Recall Bulletin

PRODUCT SAFETY RECALL

SUBJECT: Electric Power Steering Assist

MODELS: 2006-2007 Chevrolet Malibu, Malibu Maxx
2006-2007 Pontiac G6
Equipped with Electric Power Steering

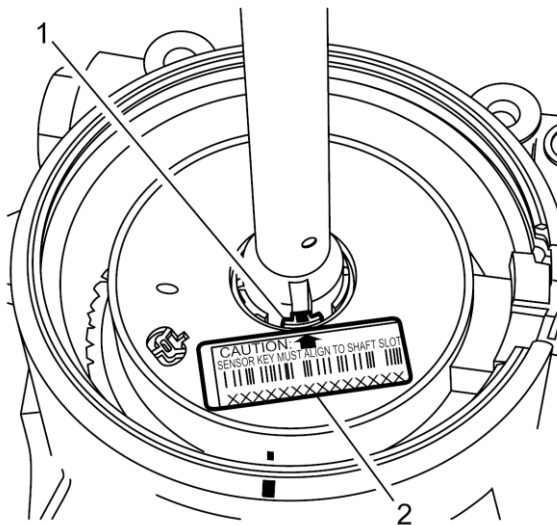
Note: Carefully read and follow the important steering shaft torque sensor replacement tips below:

- Before starting the repair procedure, slightly turn the wheel in both directions to remove any load (torque).
- The new sensor should be handled with care while it is being prepared for installation.

- The alignment pin should be centered during all of the installation steps and must not be removed until the new sensor is fully installed and aligned. It is very important to follow the alignment pin removal instructions included in the SI procedure.

- It is critical to use the supplied alignment tool before, during and after the installation of the new sensor.

- Before starting the calibration process, TURN ON the ignition with engine OFF and remove hands or any other objects from steering wheel to avoid any load (torque). Repeat step if needed. Cycle the ignition OFF then turn it ON.

3. Document the last 9 digits of the NEW steering shaft torque sensor on the vehicle repair order. The serial number is located on the bottom of the caution label (2).
